Access Compliance Report

Public Rights-of-Way

(Curb Ramps)

Intersection ID: 29738	Main Street: KING_ARTHUR_DR	Cross Street: MERLIN_MEADOWS_CT	Location: N
ADA ID: 877909631C94	Ramp Type: PerpDiag	Initial Pass/Fail: Fail	Overall Compliance: No
Codes/Mitigation Info/Possible Solution		Field Measurements/Component Compliance

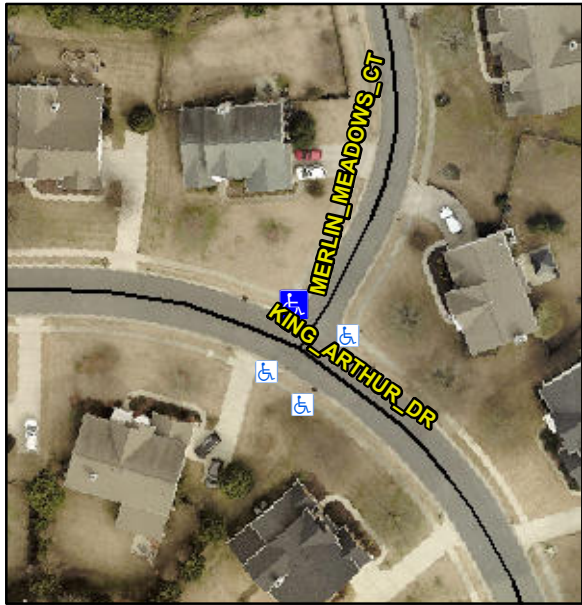
Not Found, R304.2.2, R304.5.3

Compliance		Description	Data	Compliance	Description	Data
N/A	Ramp Length (in)	48.0	No	Ramp Slope (%)	8.5	
Yes	Ramp Width (in)	48.0	No	Ramp XSlope (%)	2.3	
N/A	Flare Type LT	N/A	N/A	Flare Type RT	N/A	
N/A	Flare Slope LT (%)	N/A	N/A	Flare Slope RT (%)	N/A	
N/A	Flare Traversable LT?	N/A	N/A	Flare Traversable RT?	N/A	
N/A	Landing Length (in)	N/A	N/A	DWS Provided?	N/A	
N/A	Landing Width (in)	N/A	N/A	DWS Contrast?	N/A	
N/A	Landing Slope (%)	N/A	N/A	DWS Length (in)	N/A	
N/A	Landing X Slope (%)	N/A	N/A	DWS Full Width?	N/A	
N/A	Landing Curb? (Y/N)	N/A	N/A	DWS Offset (in)	N/A	
N/A	Shared Landing?	N/A				
N/A	Gutter Ponding?	N/A	N/A	Gutter Slope (%)	N/A	
N/A	Gutter Lip Ht (in)	N/A	N/A	Gutter X Slope (%)	N/A	
N/A	Painted X Walk1?	No	N/A	Painted X Walk2?	No	
	X Walk 1 Direction	To SW		X Walk 2 Direction	To SE	
N/A	X Walk 1 Width (in)	N/A	N/A	X Walk 2 Width (in)	N/A	
	X Walk 1 Slope (%)	0.9		X Walk 2 Slope (%)	0.9	
	X Walk 1 X Slope (%)	2.6		X Walk 2 X Slope (%)	3.1

Remove & Replace Curb Ramp With Two New Directional Ramps or Equivalent.
